***Planning Department
Transportation Development Services***

**Re: Nelson-Hawkins Lot #16-A(1)
4616 Hawkins St., NE
Traffic Circulation Layout
Engineer's/Architect's Stamp dated 11-16-15 (D17-D104)**

Based upon the information provided in your submittal received 11-18-15, the above referenced plan cannot be approved for Building Permit until the following comments are addressed:

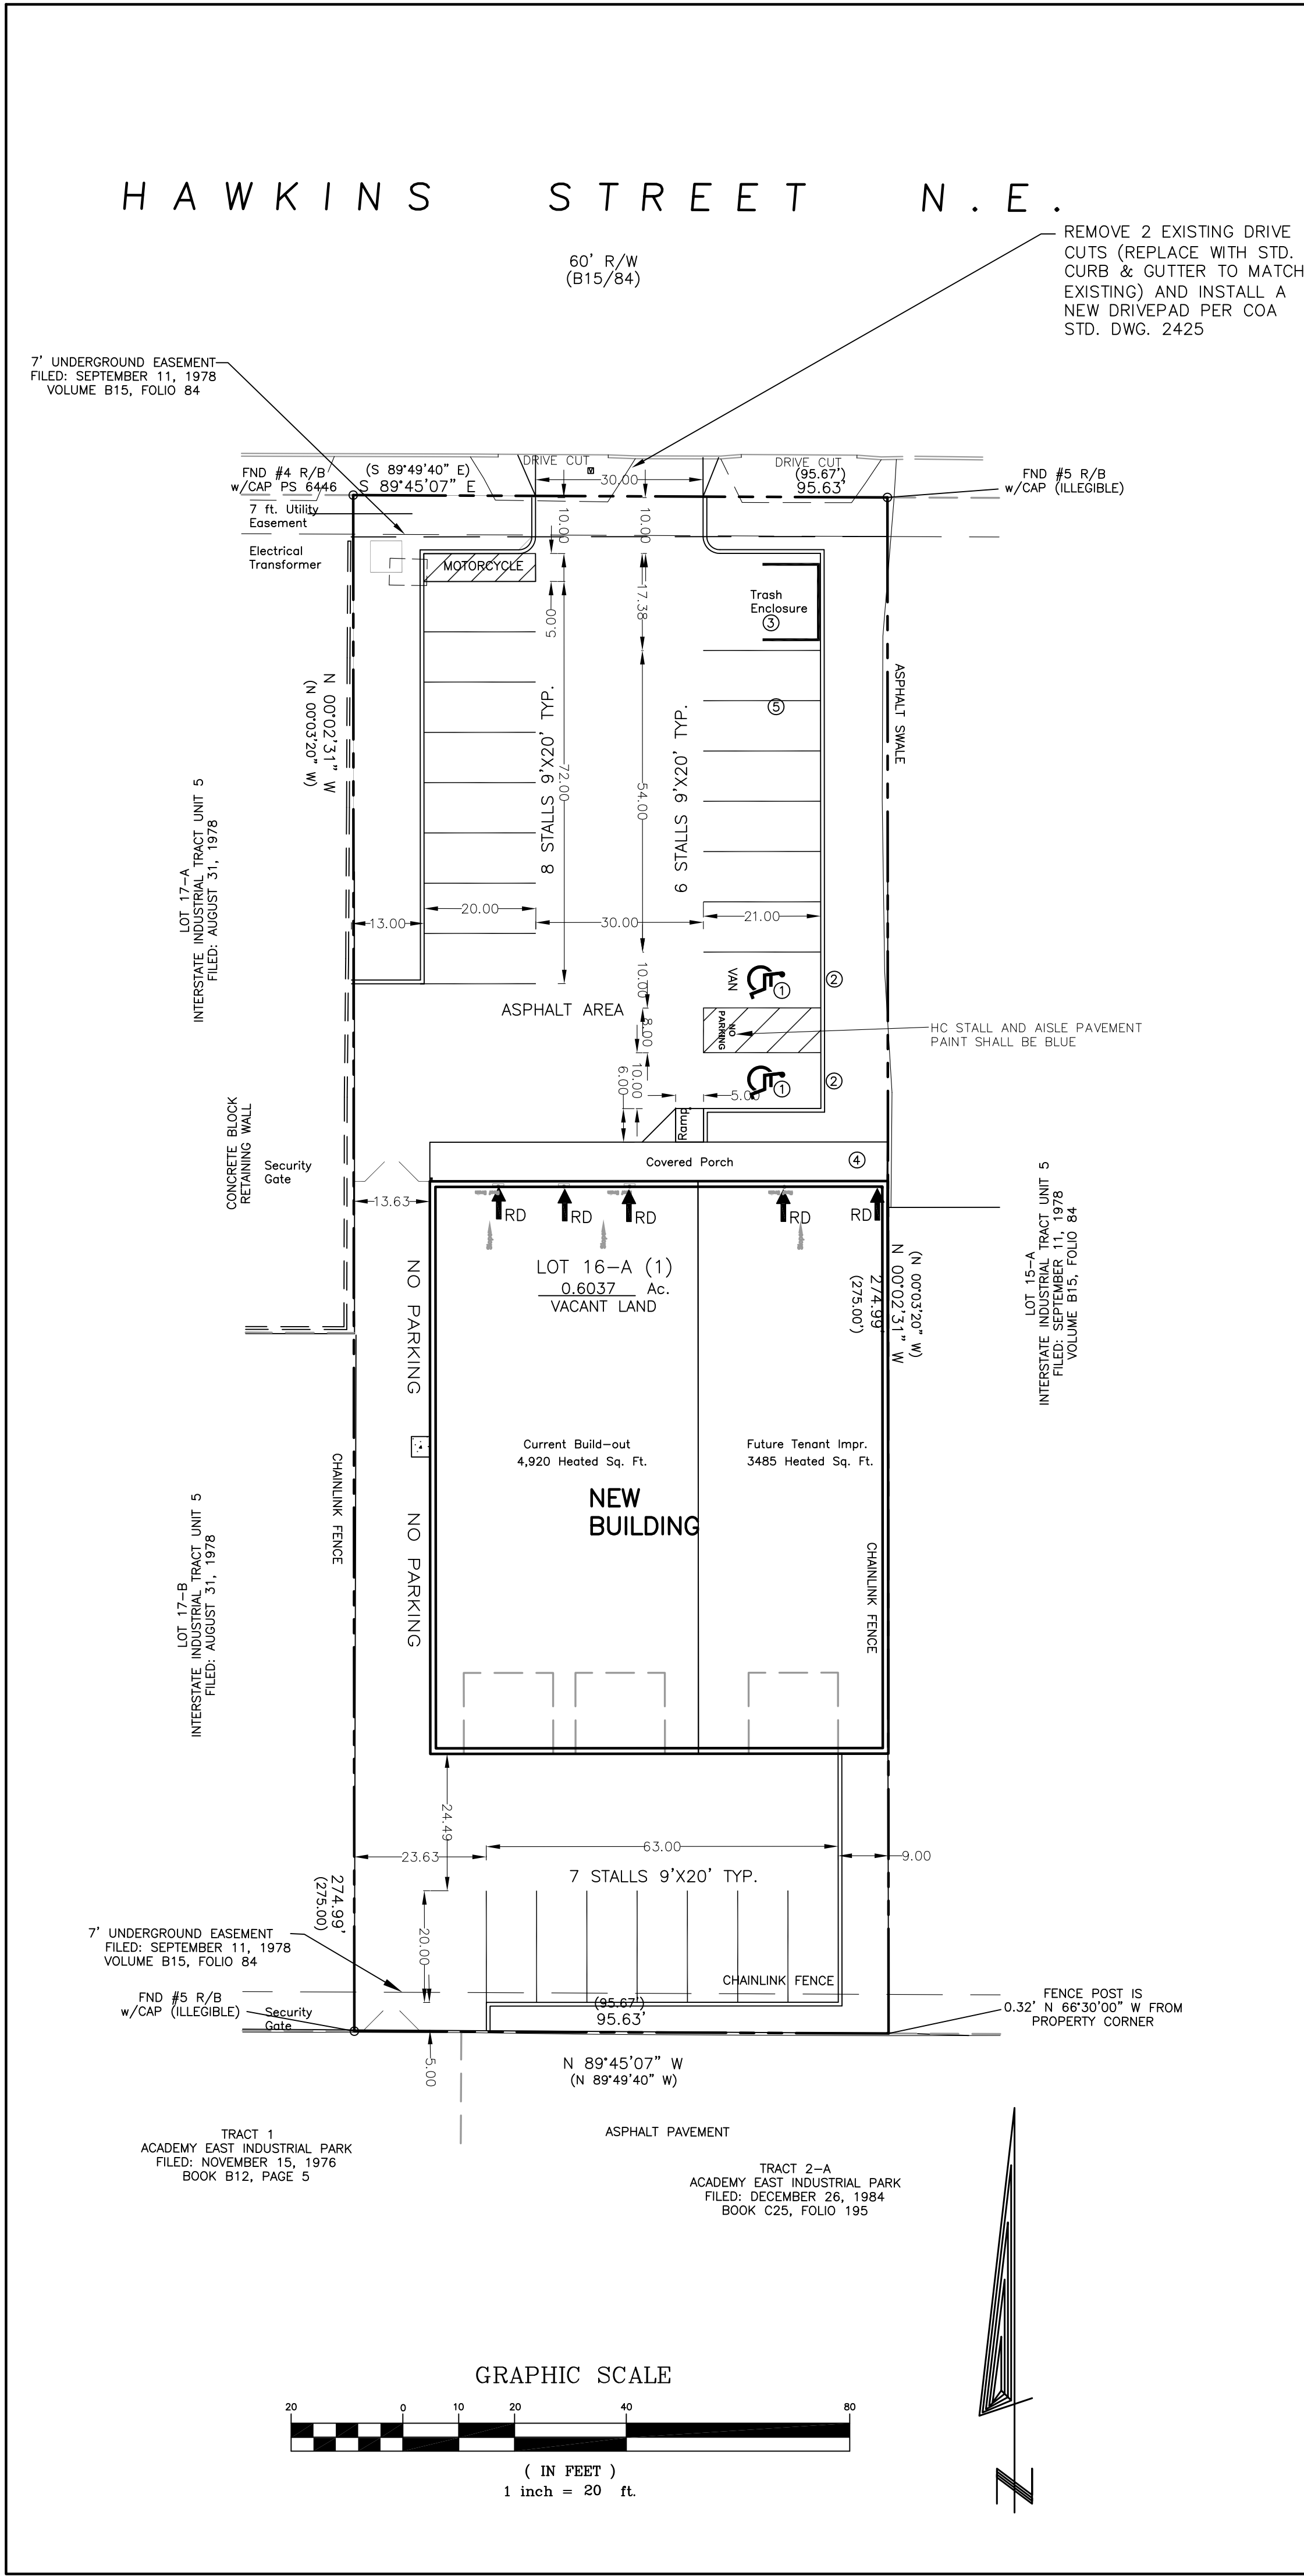
1. Please identify all existing buildings, doors, structures, sidewalks, walls and anything that influences the parking and circulation on the site. Please include the dimensions of the covered porch.

2. Show all curb radii.
3. The drive pad width for two-way traffic to the parking spaces located at the south end of the building must be 24 ft. min.
4. A 5 ft. keyway is required for dead-end parking aisles.

5. Please state the type of material to be used for the parking lot on the south end of the project site.
6. Per the DPM, a 6 ft. wide ADA accessible pedestrian pathway is required from the public sidewalk to the building entrances. Please clearly show this pathway and provide details from Hawkins St. Provide detail of ADA ramp from public R.O.W.

7. Per the DPM, a 6 ft. wide ADA accessible pedestrian pathway is required from the HC parking stall access aisles to the building entrances. Please clearly show this pathway to the building entrance.

8. Provide a min 6" or max 8" high concrete barrier curb or other acceptable barrier between landscaping and parking areas and/or drive aisles.
9. Design delivery vehicle route needs to be shown.

10. Service vehicle and/or refuse vehicle maneuvering must be contained on-site; provide a copy of refuse approval.

11. Please provide a sight distance exhibit (see the *Development Process Manual, Chapter 23, Section 3, Part D.5 Intersection Sight Distance*). Please show this detail for the entrance/exit on Hawkins St.

12. Please add the following note to the clear sight triangle: "Landscaping and signage will not interfere with clear sight requirements. Therefore, signs, walls, trees, and shrubbery between 3 and 8 feet tall (as measured from the gutter pan) will not be acceptable in this area."
13. Unused curb cuts must be replaced with sidewalk and curb & gutter. A build note must be provided referring to the appropriate City Standard drawing.
14. Please include two copies of the traffic circulation layout at the next submittal.
